## Public Comment No. 4-NFPA 2001-2023 [ Section No. 4.4.1 ]

**Public Comment No. 3-NFPA 2001-2023 [ New Section after 9.4.10 ]****9.4.10.3**

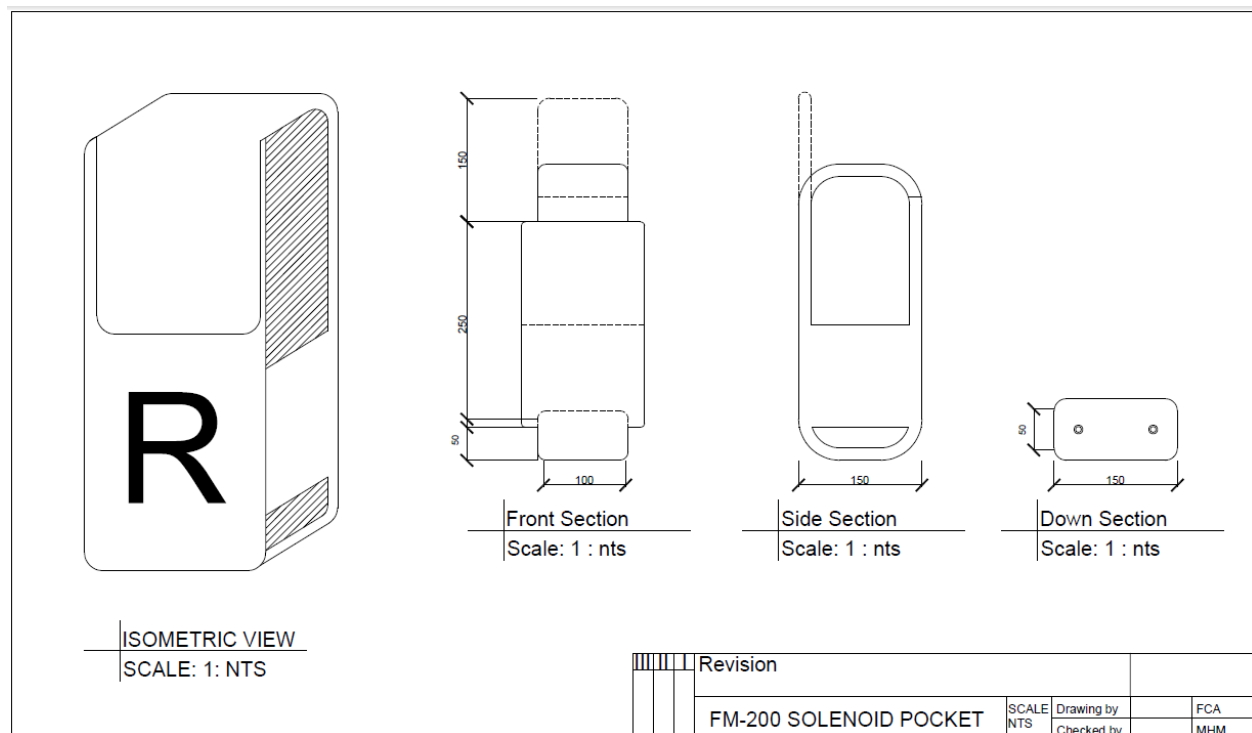
The electric actuator that removed from the agent storage container discharge valve shall be secured and placed on actuator holder or solenoid pocket to prevent mechanical damage and loss of integrity.

<u>File Name</u>	<u>Description</u>	<u>Approved</u>
Solenoid_Pocket_SOKET_.png	Before and After using Solenoid Pocket	
General_Specification_SOKET.pdf	General specification for SOKET not limited to other actuator holder

Actuator broken is one of the major problems for functional failure of FM-200 system based on comprehensive analysis and evaluation. This condition can make liquid loss and unreadiness of FM-200 system. Mechanical damage resulted from disconnection process on FM-200 system as no bracket or pocket to hold and secure actuator while maintenance or testing process. In current situation there is no statement to secure or hold the actuator, it has not been stated on Appendix A.9.4.10.1 (NFPA 72, 14.2.6.4 requires that "Suppression system shall be secured from inadvertent actuation, including disconnection of releasing solenoids or electric actuator, closing of valves, other actions, or combinations thereof, for the specific system, for the duration of the fire alarm system testing.") how the technical procedure or process of securing the solenoid while fire alarm system testing. It's highly recommended to add additional statement to prevent similar condition in other places by adding actuator holder or solenoid pocket as the solution for this problem.

**Committee Action:** Rejected  
**Resolution:** Section 9.4.5 already requires that operating devices are protect so that they are not subject to mechanical damage. Therefore, this additional requirement is not necessary.
